HISTORIC CONSERVATION BOARD AGENDA

Monday, September 12, 2016 at 3:00 pm

APPLICATION FOR CERTIFICATE OF APPROPRIATENESS HISTORIC CONSERVATION BOARD PUBLIC HEARING STAFF REPORT

APPLICATION #:
APPLICANT: Beck Architecture
OWNER: David Gaudi and Amy Roberts
ADDRESS: **524 Milton Street, Cincinnati OH 45202**
PARCELS: 086-0001-0069
ZONING: Residential Multi-Family (RM 1.2)
OVERLAYS: Prospect Hill Historic District
COMMUNITY: Over the Rhine
REPORT DATE: August 30, 2016
HEARING DATE: Prehearing August 17, 2016
STAFF REVIEW: Beth Johnson, Urban Conservator

**PROPOSED
ELEVATION**

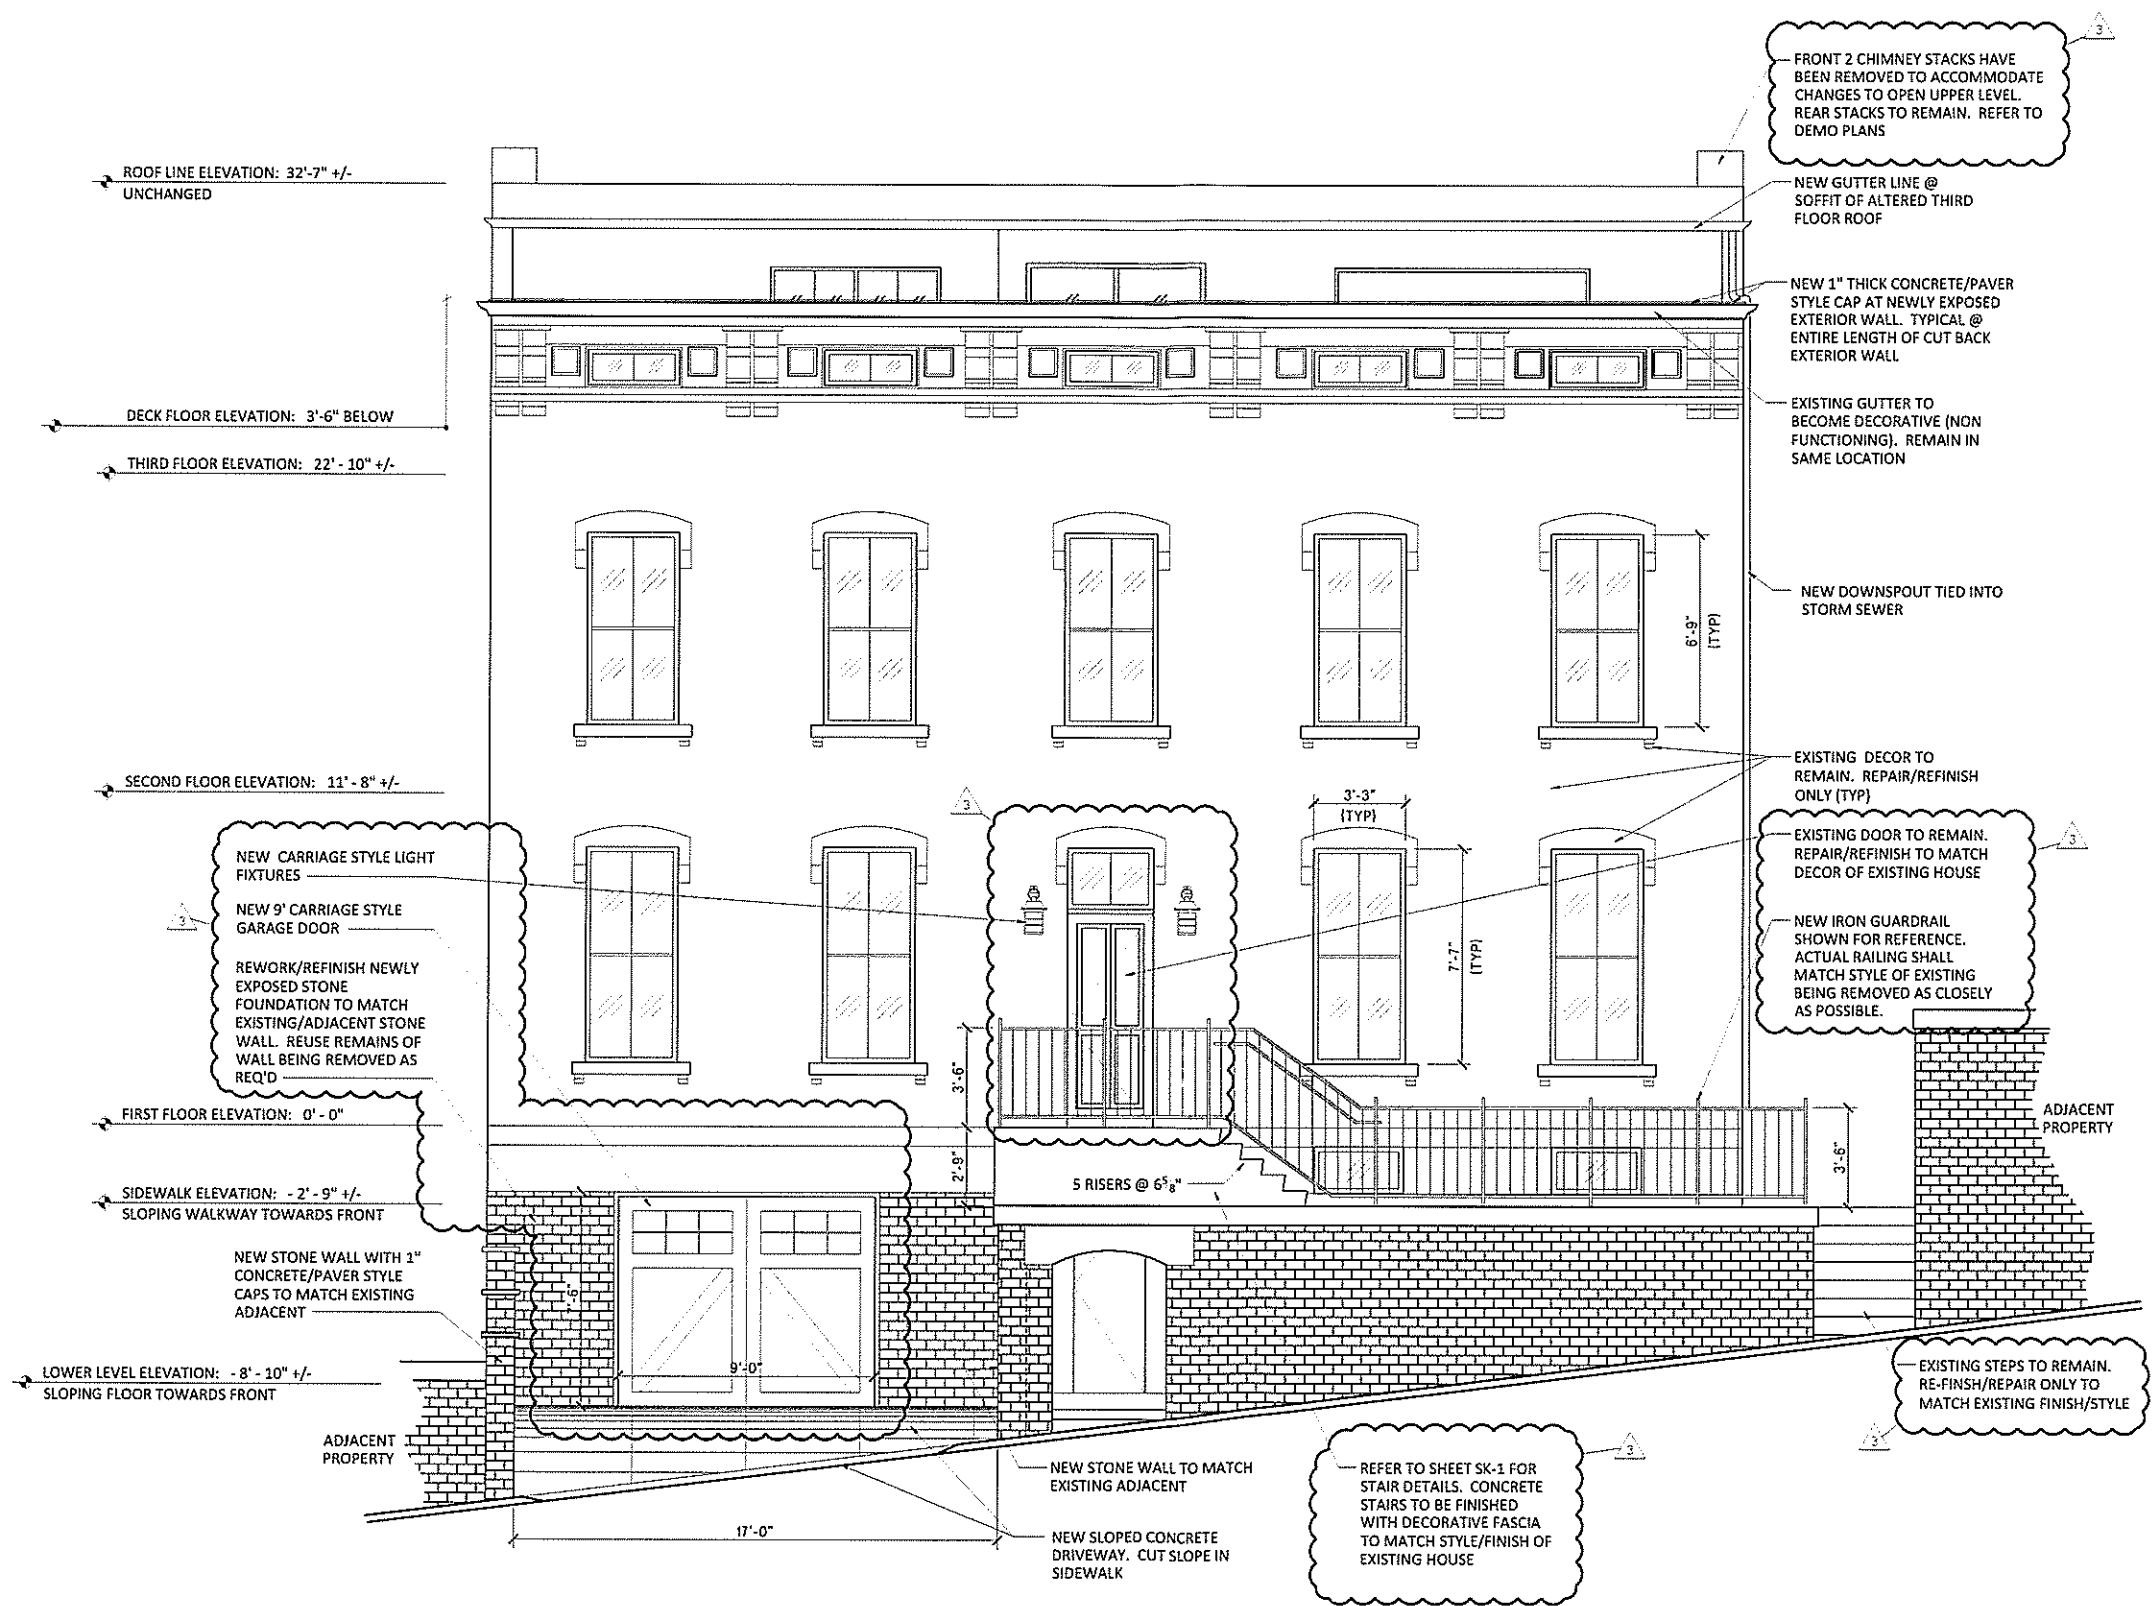
- 2) Clad the shaft in brick
- 3) Provide articulation in banding on the elevator shaft material
- 4) The garage door to be lowered so it doesn't interfere with the water table on the house.
- 5) The garage door be a carriage style door
- 6) The garage door be 9 foot in width
- 7) Fencing is to be code compliant and match the existing fence in material and style
- 8) New concrete stairs must have a fascia cladding to match the historic wall.
- 9) The new front door must match the historic front door in material and design
- 10) Carriage style light on exterior doors
- 11) New stairs to the street must be clad with a stone material
- 12) New sides where the roof deck is altering the roof line must be clad in brick and not hardi-plank

The original façade that was submitted for review is Attachment A and the revised façade submitted to include the above conditions is Attachment B.

E1 BUILDING ELEVATIONS
 3/16"=1'-0" SERVICE COURT ELEVATION (EAST)

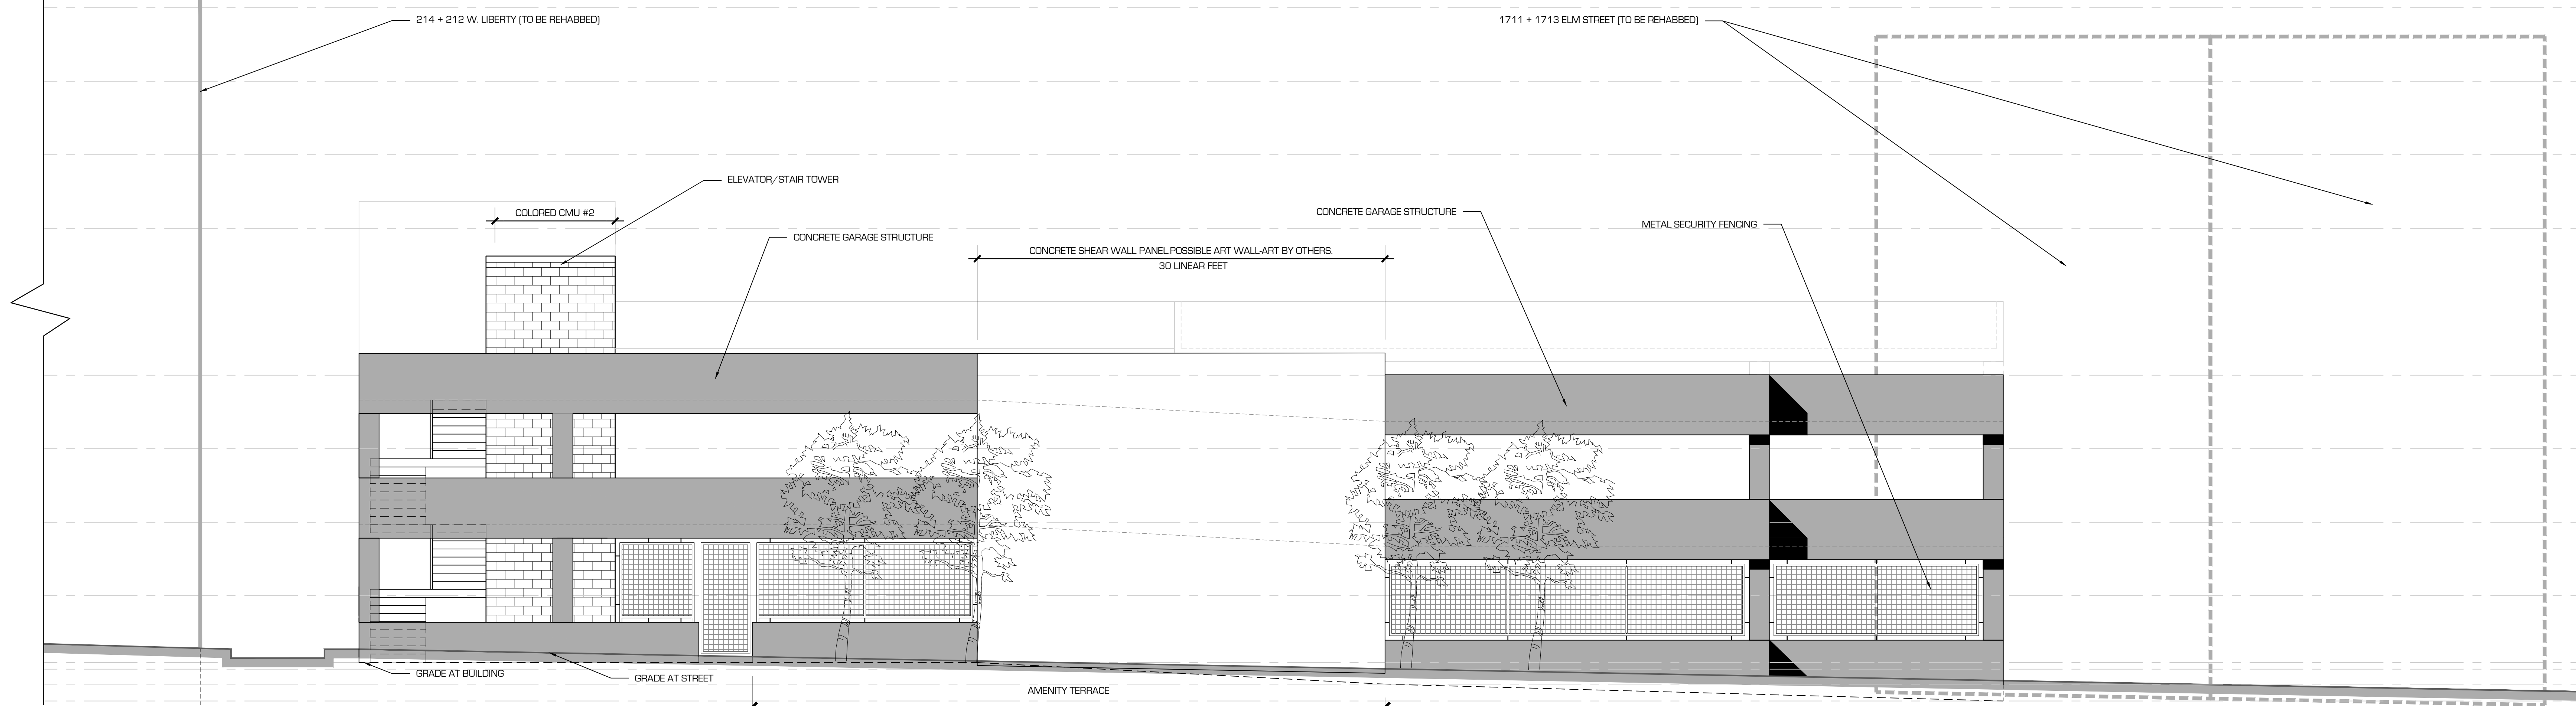
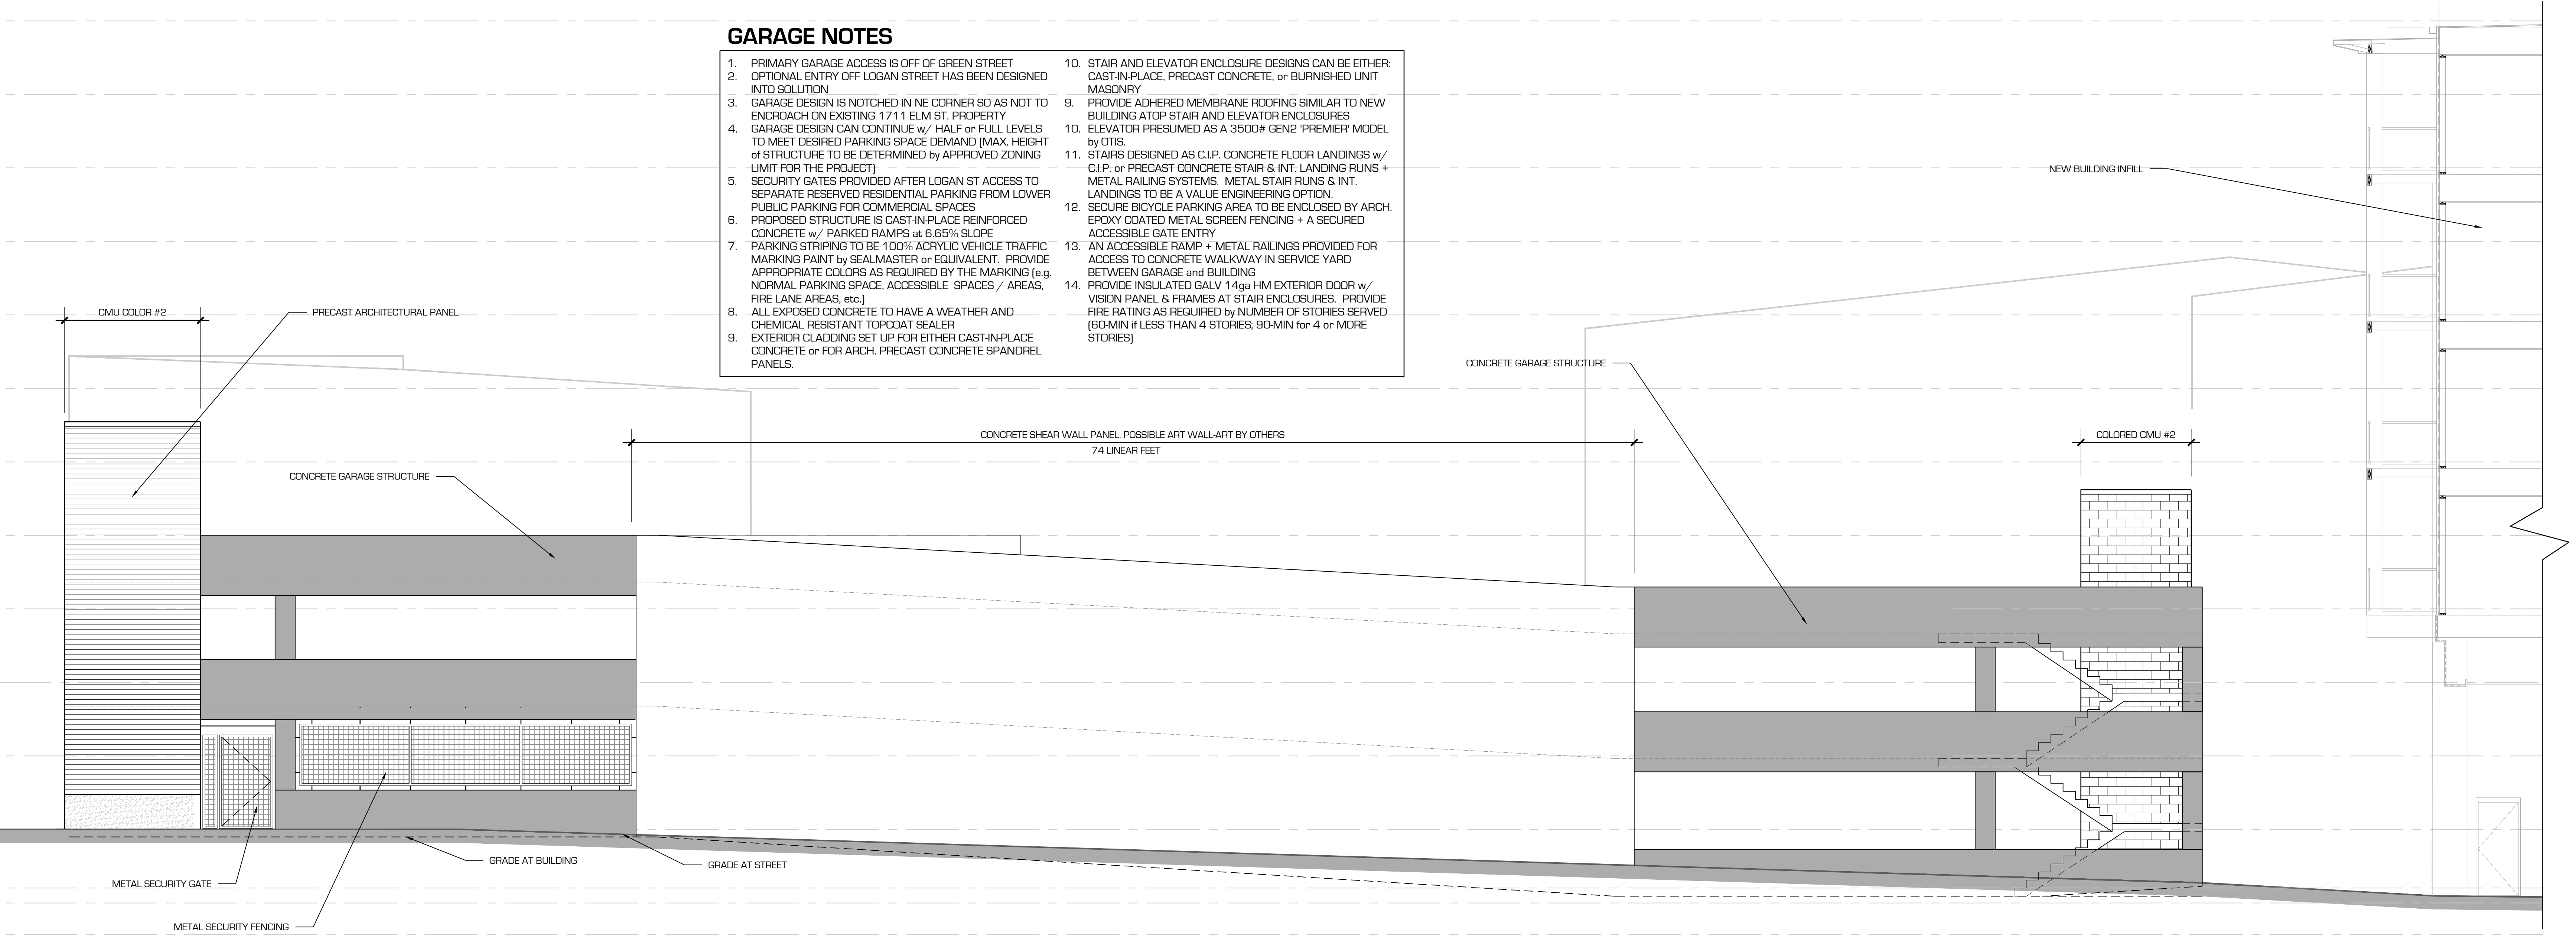
Large murals are shown on garage elevations. If they are to be a part of the approved design how is the developer guaranteeing they will be produced? Are murals a replacement for architecture that is consistent with the guidelines? The committee supports community collaboration on public art, but more information about that process and commitment is needed.
